## HAYS AREA BOARD OF ZONING APPEALS MEETING

Monday, June 16, 2025 – 4:00PM

<b>Agenda Item:</b>	Setback Variance for a Carport at 1600 E. 29 <sup>th</sup> St.
<b>Owner:</b>	Dave & Shelia Eichman
<b>Type of Review:</b>	Consider a Setback Variance for a Carport at 1600 E. 29 <sup>th</sup> St.
<b>Presented By:</b>	Curtis W. Deines, Planning & Development Superintendent
<b>Date Prepared:</b>	June 4, 2025
<b>Agenda Date:</b>	June 16, 2025

<b>Agenda Item:</b>	Size and Height Variance for a Monument Sign for Hays High Campus at 2300 E. 13 <sup>th</sup> St.
<b>Owner:</b>	USD 489
<b>Type of Review:</b>	Consider a Sign Variance for Size and Height
<b>Presented By:</b>	Curtis W. Deines, Planning & Development Superintendent
<b>Date Prepared:</b>	June 4, 2025
<b>Agenda Date:</b>	June 16, 2025

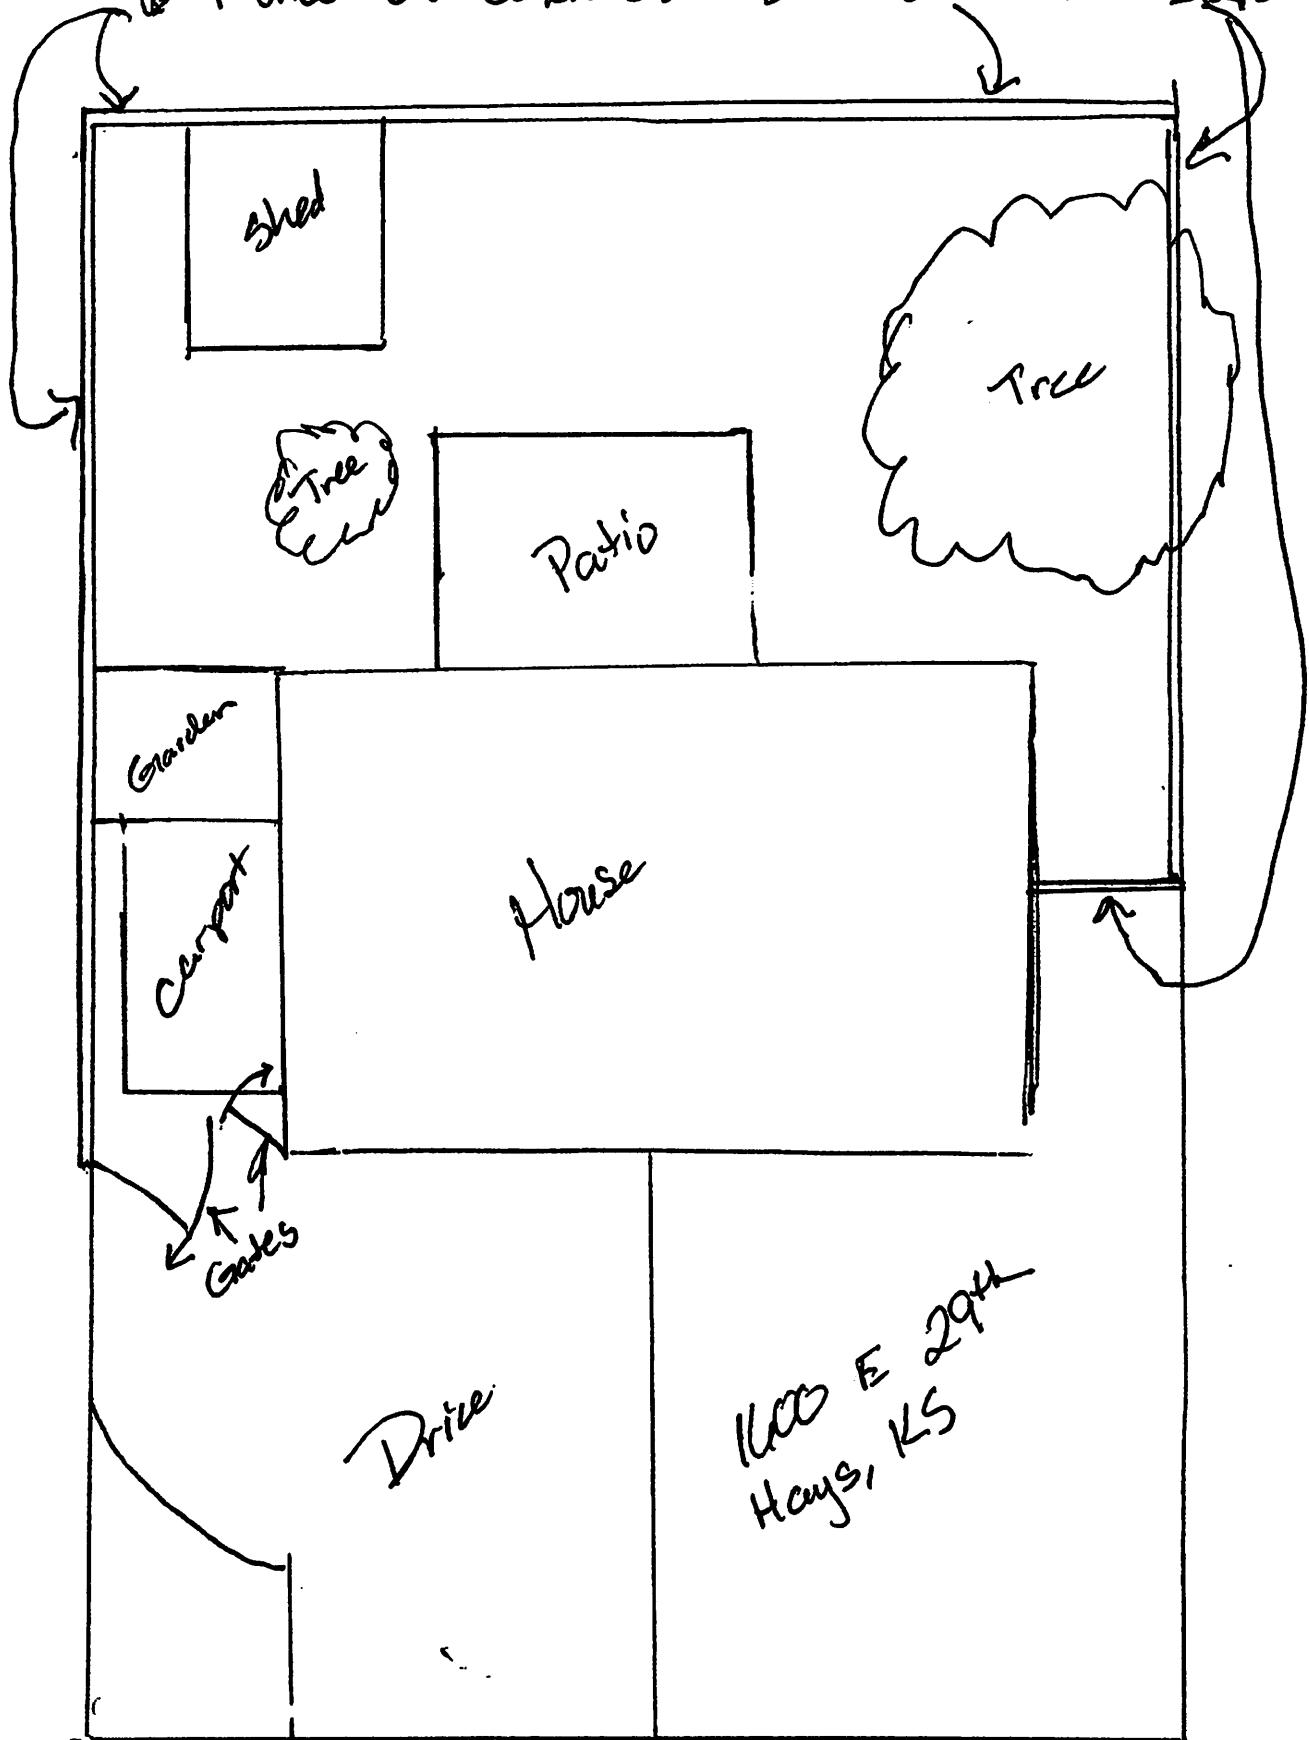
**Staff Analysis:** *The property is not irregularly shaped compared to other lots on the block and surrounding blocks. There are several other houses that are the same shape and size. There is a concrete retaining wall that ranges in height around the rear yard and street side, making vehicle access from that area difficult.*

**Staff Analysis:** *Even though the proposed carport would still be located on the applicant's property, the proposed request could adversely affect the rights of the adjacent property owners due to the carport possibly being placed within 2' of the adjacent property owner's property line.*

**Staff Analysis:** *The request could be considered a self-imposed hardship since there is room to relocate the carport further into the backyard and access the carport from the front yard.*
